AEBN: 090809

Date: 09/08/09

Subject: RS-232 DB-9 Connection Diagram, E-FSA64 & E-FSA250

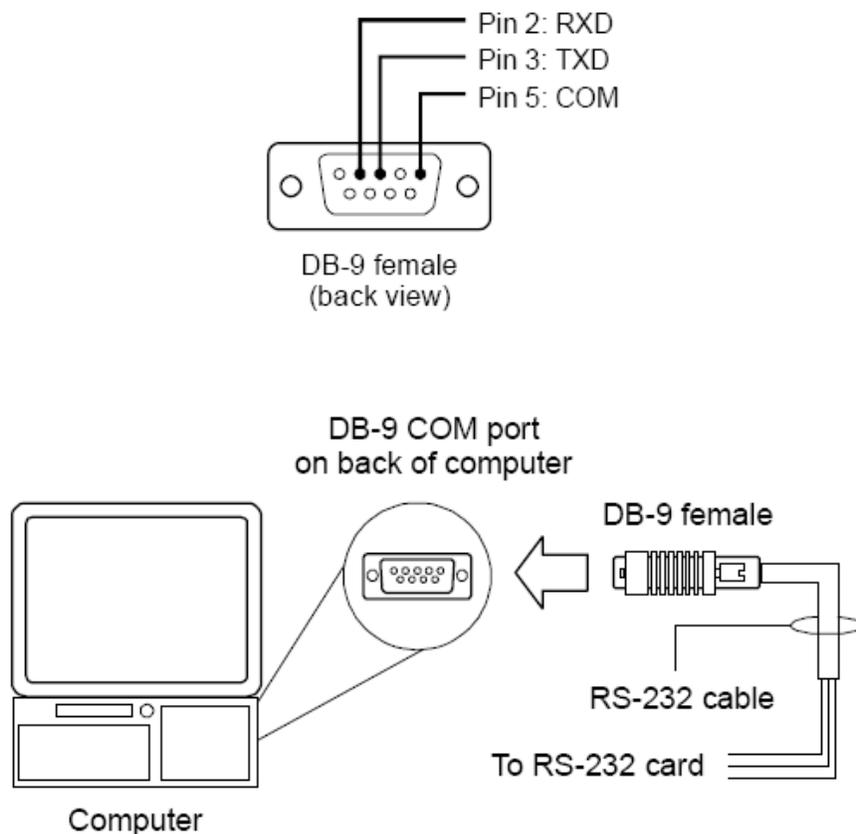
The DB-9 pin connection diagrams for the RS-232 cable illustrated in the E-FSA Technical Reference Manual 3101202 (rev. 2) and SA-232 Installation Sheet 3101095 (rev. 1.04) are labeled incorrectly. The connector shown should be a female, looking from the backside (side where wires solder to connector).

The correct diagrams are shown below.
